ISSUE: Permit to Demolish/Capsulate (partial), Certificate of Appropriateness for alterations

APPLICANT: Jemal's Gap Corner King, LLC

LOCATION: Old and Historic Alexandria District
628 King Street

BAR #2022-00064 & BAR #2022-00065
628 King Street

Figure 2: 628 King north elevation (King St)

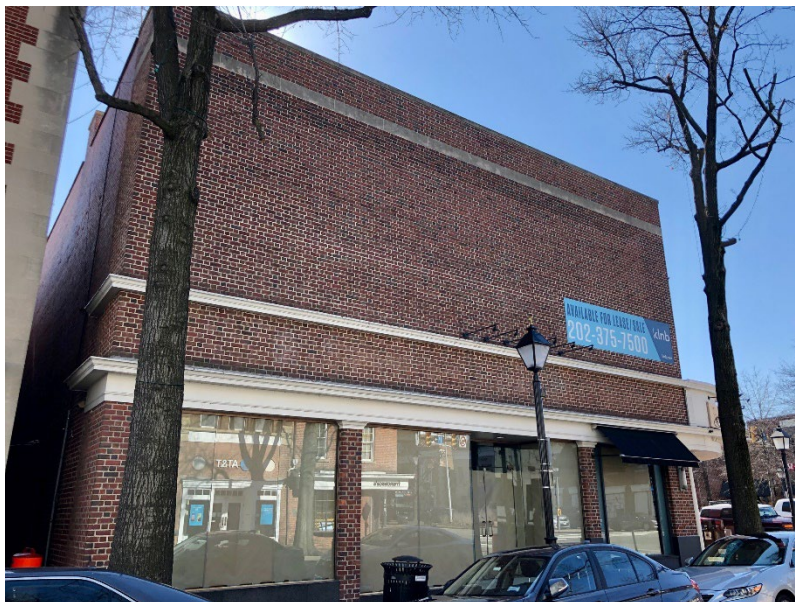
The applicant proposes demolishing 1171 square feet of the north and west elevations of the building. In so doing, the applicant intends to replace much of the first-floor storefront and add windows to the second floor. Staff supports the proposed demolition, as the proposed changes will improve the appearance of the building, which currently appears imbalanced and bulky due to the lack of fenestration on the second floor (Figures 2 & 3). The character-defining features of the building will be retained, and the overall proportions will be improved. The existing first-floor storefront windows were installed in 2004 and are therefore neither historic nor original. The windows and wall surfaces to be demolished are not of old and unusual or uncommon design, and they could be reproduced easily. Staff therefore recommends approval of the Permit to Demolish.

Figure 4: Proposed door canopy on west elevation

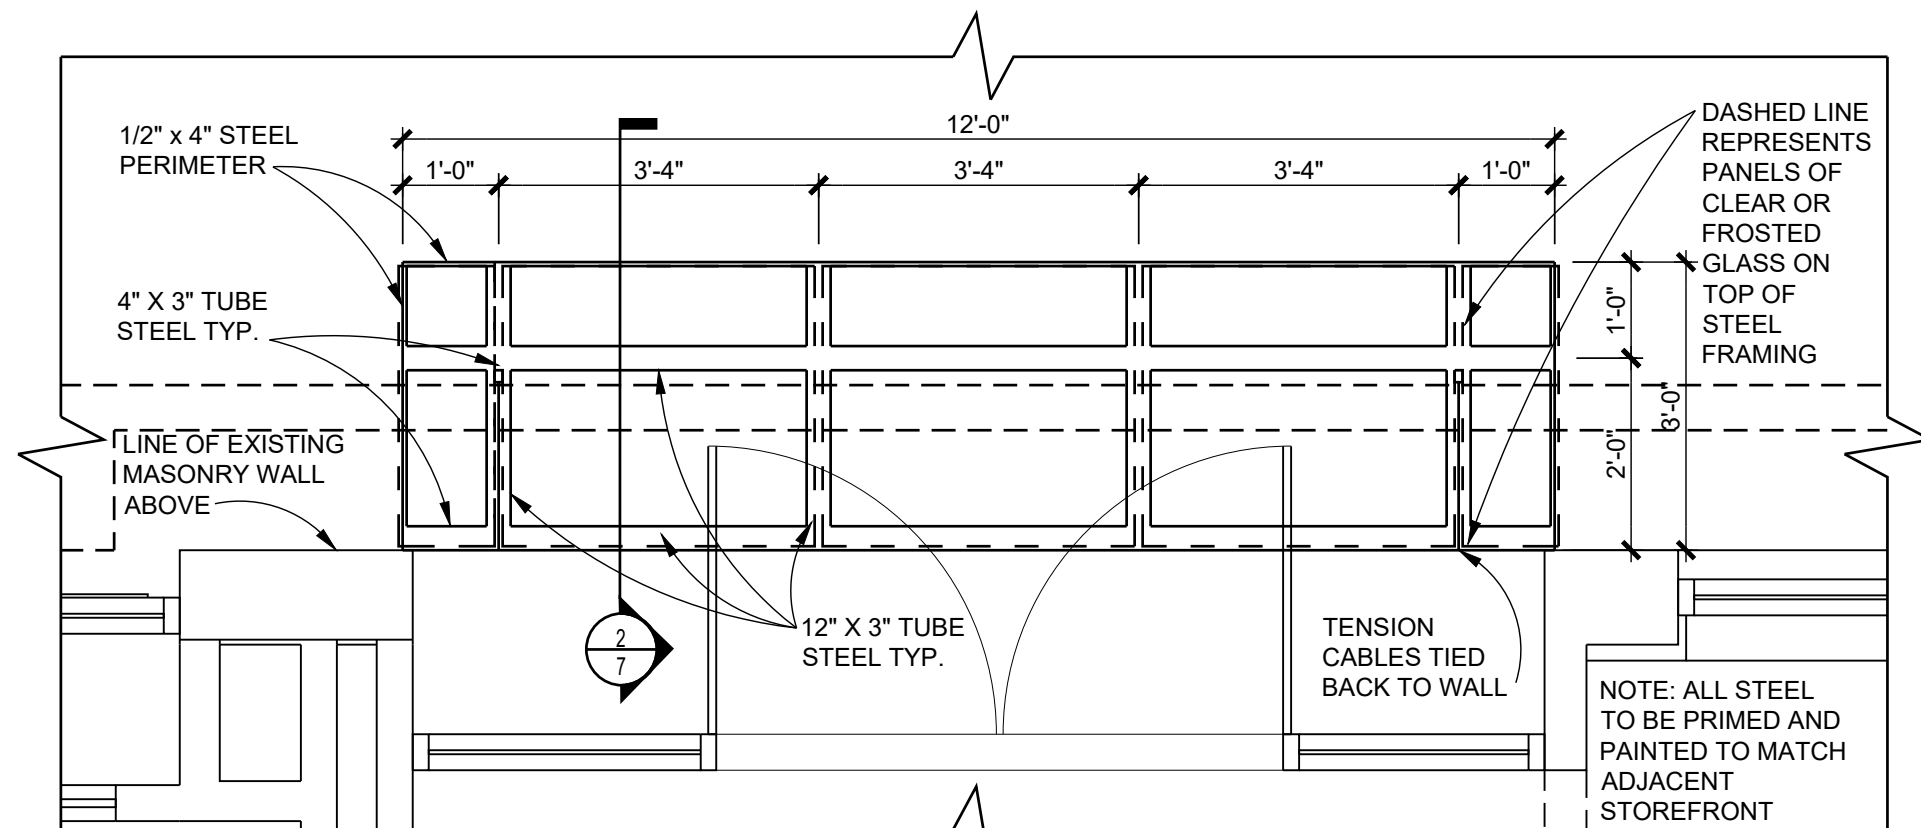
Staff finds the proposed lighting appropriate to this entry on South Washington Street. It is subtle, not overly large, does not obscure any architectural details, and the design works well with the building. These characteristics fulfill numerous *Design Guidelines*, including the recommendation that exterior lighting fixtures "...should be sympathetic to the style of the building and not detract from the architectural character." The *Design Guidelines* state that "Awnings should not overwhelm or obscure the architecture and decorative features of historic buildings." The proposed door canopy blends in well with this later building's architecture and will be black to match the storefront. See Figure 4. The *Design Guidelines* indicate a preference for canvas shed awnings that can be retracted, but staff finds the proposed canopy preferable and more appropriate than canvas. In addition to being more durable and less likely to degrade over time, the proposed canopy will look more tasteful than a canvas shed awning. Canopy materials have improved significantly since the *Design Guidelines* were written nearly 30 years ago in 1993. Staff recommends approval of the lighting and the door canopy, with the condition that the canopy be anchored through mortar joints, not brick.

- The first-floor storefront window glazing complies with *Alexandria New and Replacement Window Performance Specifications in the Historic Districts*.
- Work with staff on the color of the stone base below the storefront windows on the north elevation.
- The canopy over the door on the South Washington entrance be anchored through mortar joints.
